CNL-15-193

Subject: **WATTS BAR NUCLEAR PLANT (WBN) UNIT 2 - DISTRIBUTED CONTROL SYSTEM (DCS) DATA STORM TEST RESULTS**

**DISTRIBUTED CONTROL SYSTEM (DCS) DATA STORM TEST  
SUMMARY REPORT**

**WBN Unit 2 DCS Data Storm  
Response to NRC Questions**

**Attachment 1:  
WBN Unit 2 DCS Data Storm  
Network Layout  
(2-NC-PI-98-03 Rev 0)**

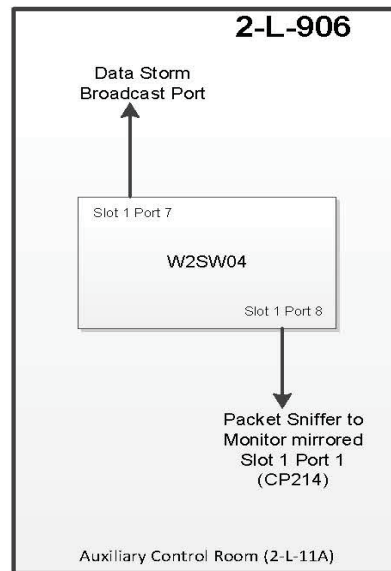
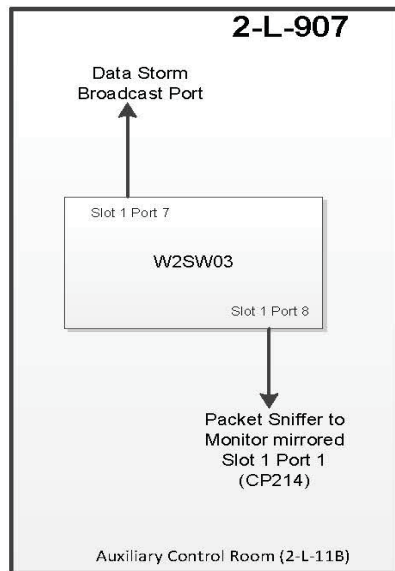
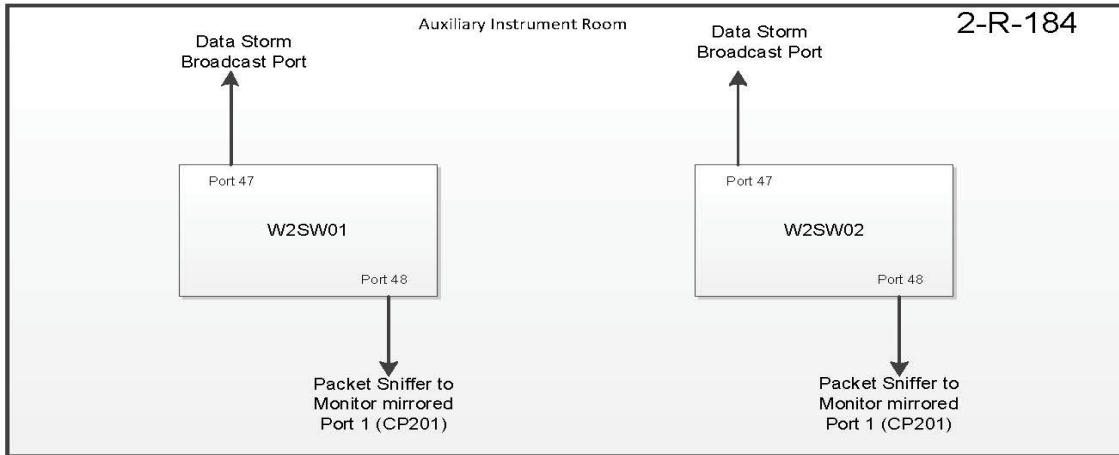
- c) *TVA performed the Broadcast and Multicast tests at each of the locations identified in the test plan.*

- e) *Verify that the test documentation recorded specifically where each packet generator was connected for each portion of the test. (Provide common controller pair function name so the staff understands the controller function involved for each portion of the test.)*

- f) *Verify that the test documentation recorded specifically where each packet sniffer was connected for each portion of the test. (Provide common controller pair function name so the staff understands the controller function involved for each portion of the test.)*

**Response:** See Attachment 1 for Network Layout and the discussion in the enclosure.

**Response:** See Attachment 1 for Network Layout and Attachment 2 for Hand-Auto Station with CP

**Response:** See Attachment 1 for Network Layout and Attachment 2 for Hand-Auto Station with CP for system connections and disconnections. Connections and disconnections are documented in Section 6 of NC-PI-98-03.
